Proposed Revisions to a Standard Plans Index

Index Number: 700-030

Index Title: WIND AND HANGER BEAMS FOR OVERHEAD
SIGNS

FRONT ELEVATION

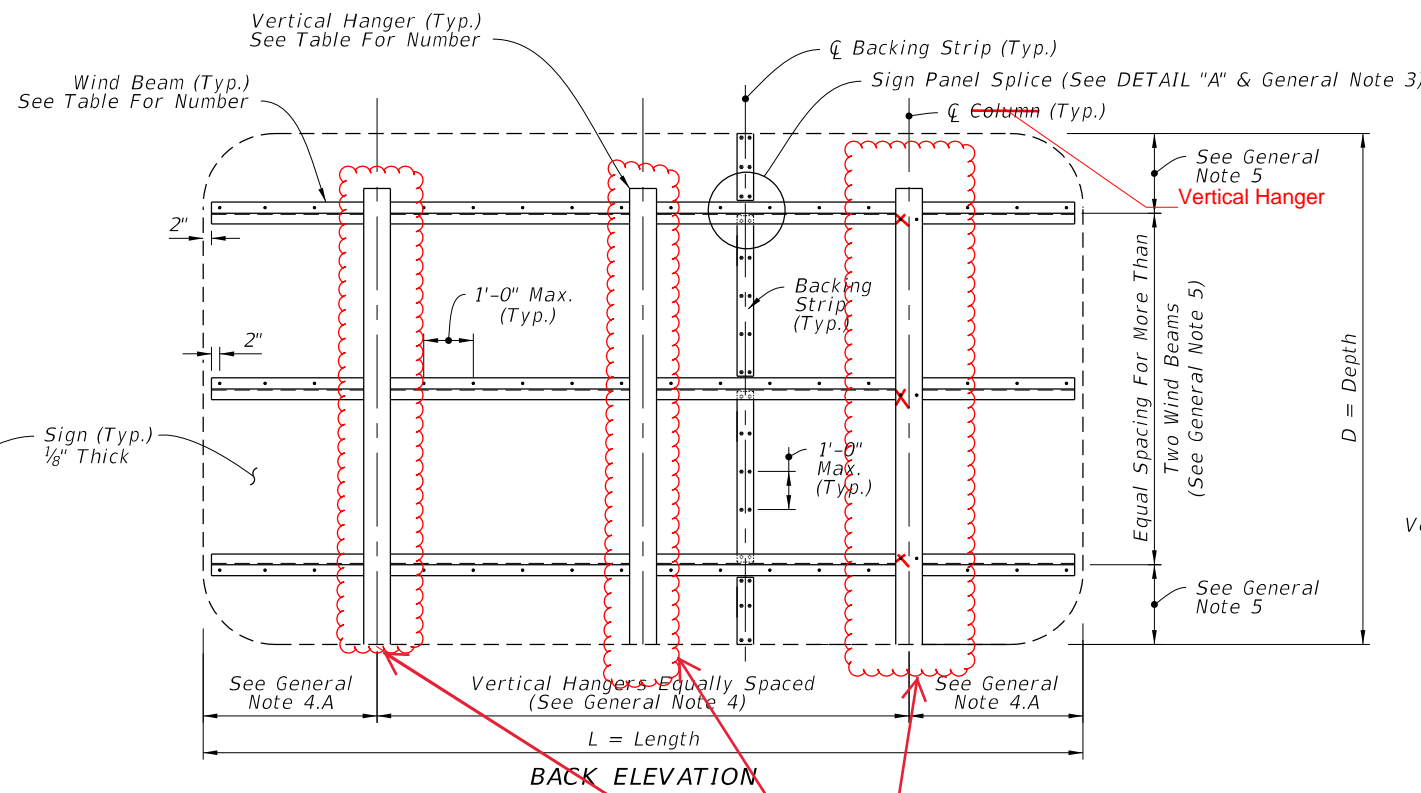
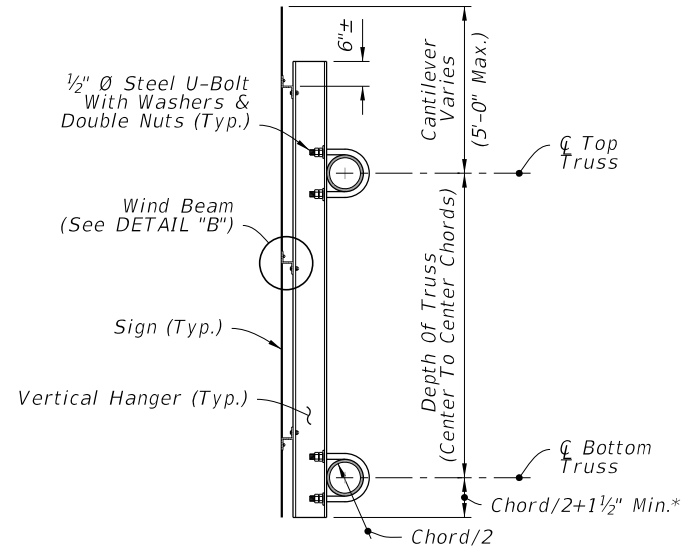
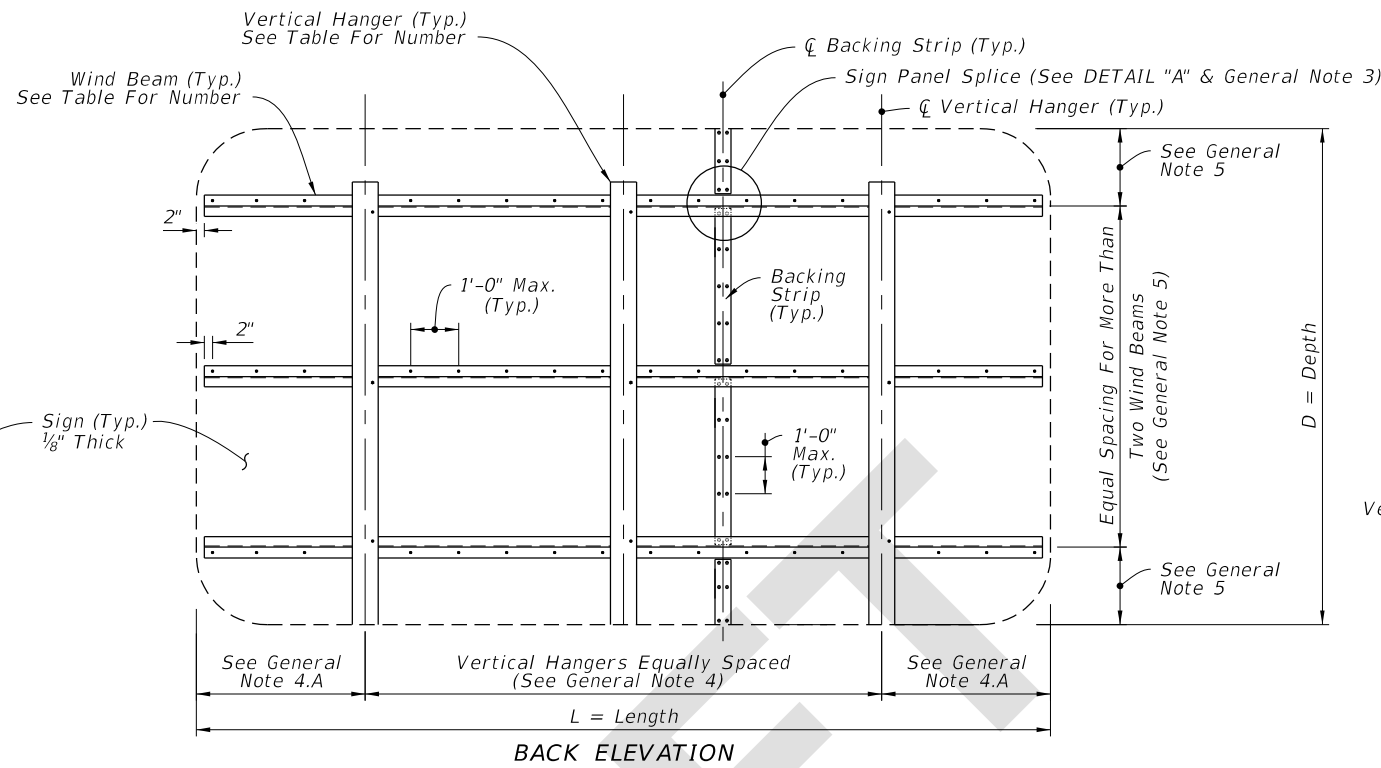
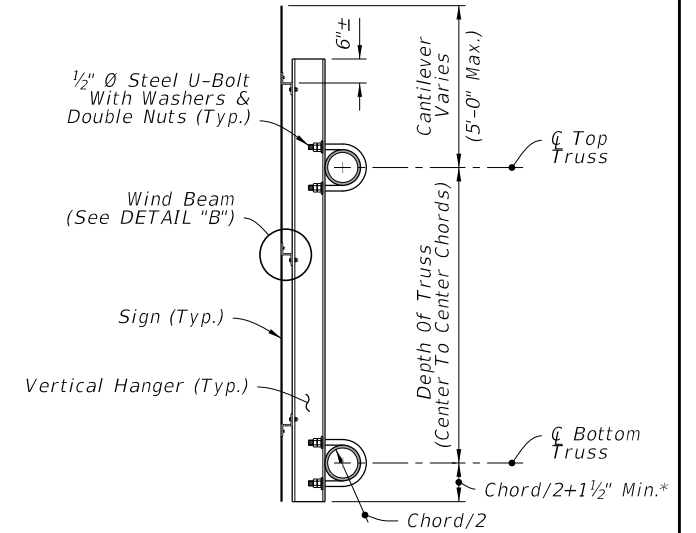
Sheet 1: Revise the bolts in the Hanger Beams to show correctly. Added language to Detail B bolt call out to clarify number of bolts required.

We received a query about the required number of bolts per intersection of the hanger beam and the wind beams. The bolts were not showing correctly in the elevation details so we corrected it.

Only show one bolt per intersection and show the bolts on the other beams as well.
